**EB-2022-0111 Bobcaygeon Community Expansion Project Leave to Construct
Pollution Probe Interrogatories to the Applicant**

**Enbridge Gas Inc.
Bobcaygeon Community Expansion Project
Leave to Construct**

POLLUTION PROBE INTERROGATORIES

Figure 1: Energy Savings (percentage) for a ccASHP compared to natural gas, oil and baseboard electric.

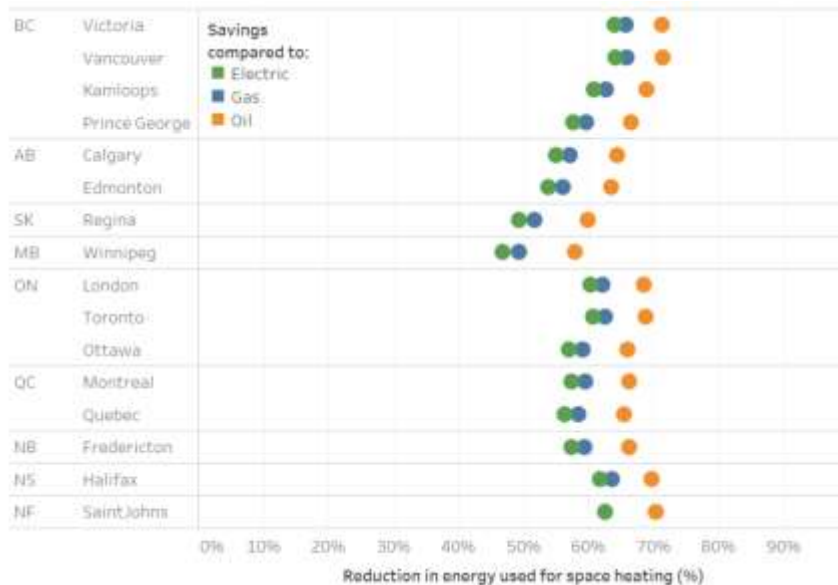
The CanmetENERGY cold-climate air source heat pump (ccASHP) Report filed by Enbridge indicates in Figure 1 (above), that for Ontario jurisdictions a ccASHP is approximately 50% to 70% more efficient than natural gas, oil or resistance (i.e. baseboard) electric.

- a) Please indicate whether this information for ccASHPs was shared with potential customers as part of the information related to heat pumps. If it was, please provide a copy of the information/materials provided to consumers.

- b) This information was provided by Enbridge in 2023 based on a 2022 Study. If Enbridge has a more recent/relevant study/information that provides a different savings rate for ccASHPs vs. natural gas, oil or electric resistance heating, please provide a copy.
